# **Russell Gap Stream Mitigation Project Year 1 (2020) Monitoring Report FINAL**

DMS Project ID No. 100003, DEQ Contract No. 6980

**Subject:** Response to DMS Comments for DRAFT MY1 Report  
Russell Gap Mitigation Project, Alexander County  
DMS Project # 100003, DEQ Contract #6980, Catawba River Basin

Figure 5. Wetland Monitoring Well Graphs

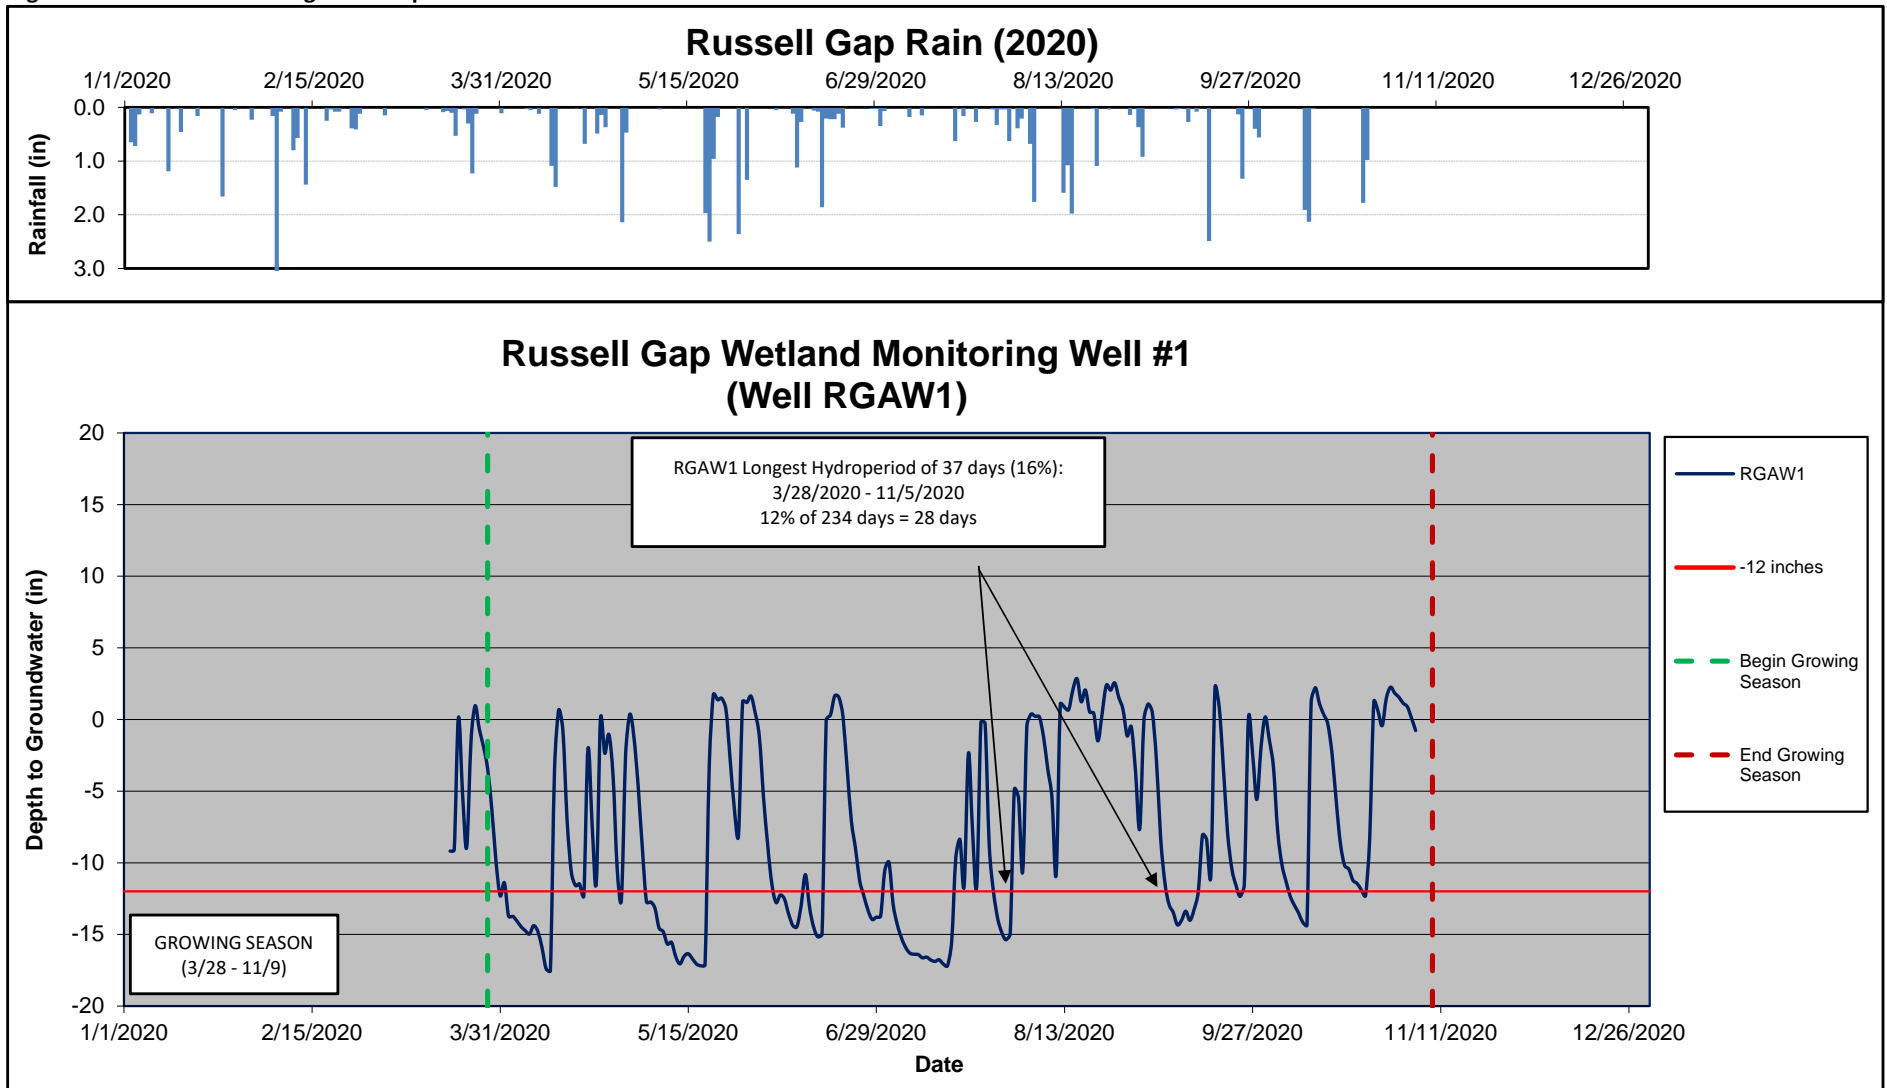
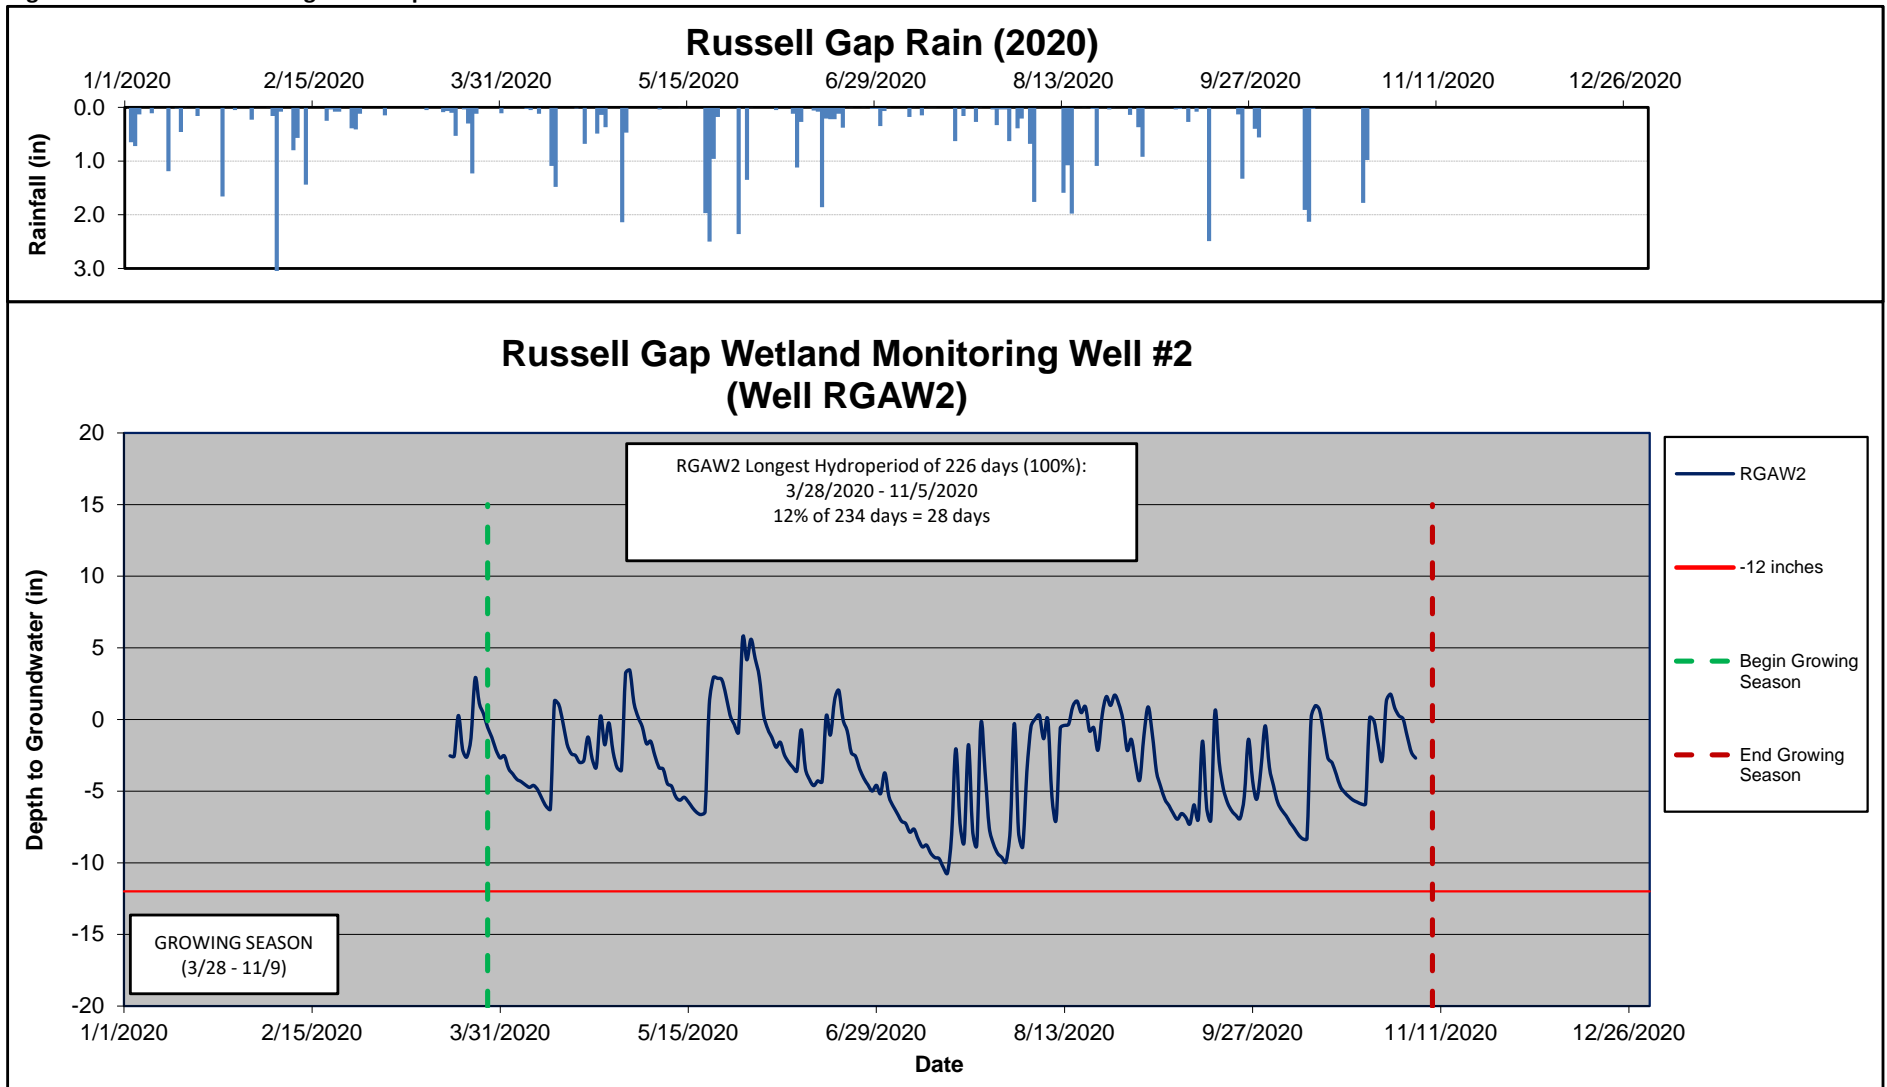
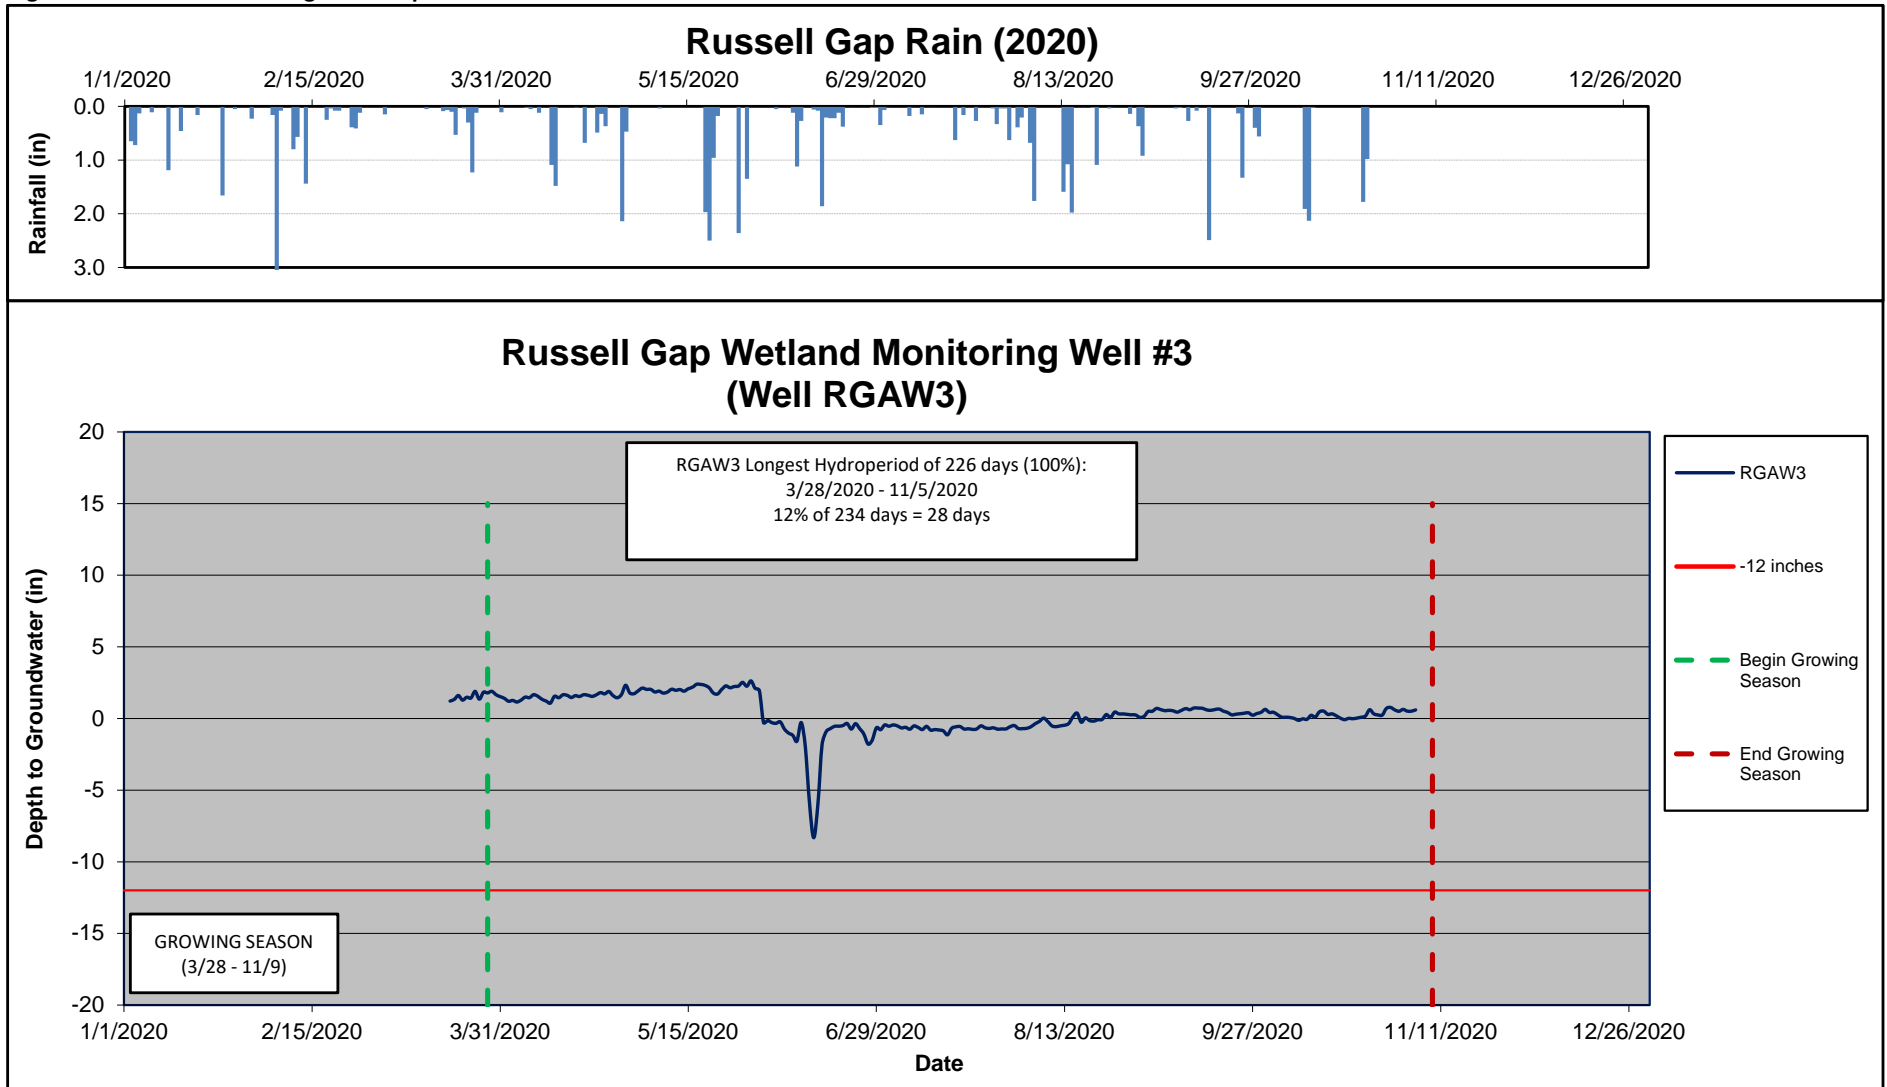
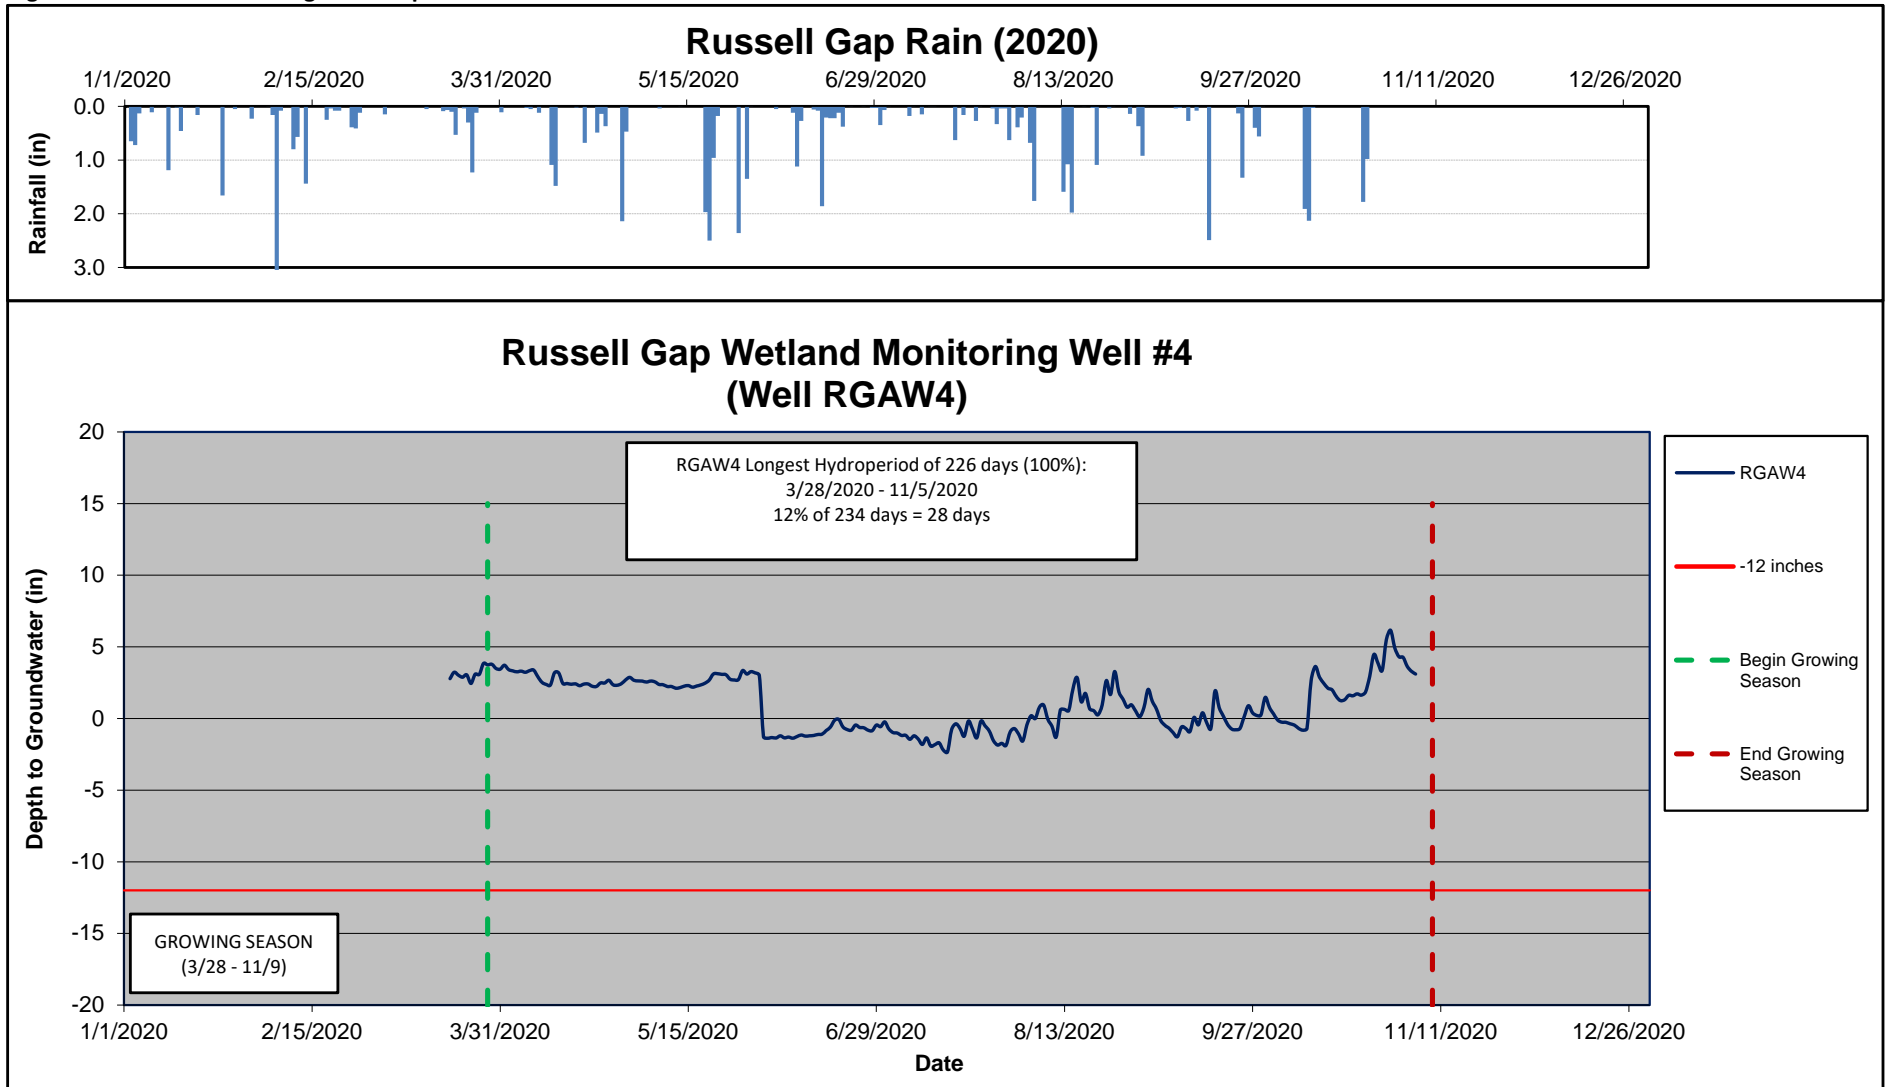
- Table 8: Please add grid lines to aid in reviewing report.  
**Response: Revision made as requested.**
- Wetland Monitoring Well Graphs: Consider adding a note indicating the hydroperiod performance criteria that was approved in the Mitigation plan of “12% of 234 is 28 days” or something similar.

**Response: Revision made as requested.**
- Flow Gauge Graphs: The note for the Daily Rain portion indicates data is from onsite gauge from the Browns Summit site. Please revise.
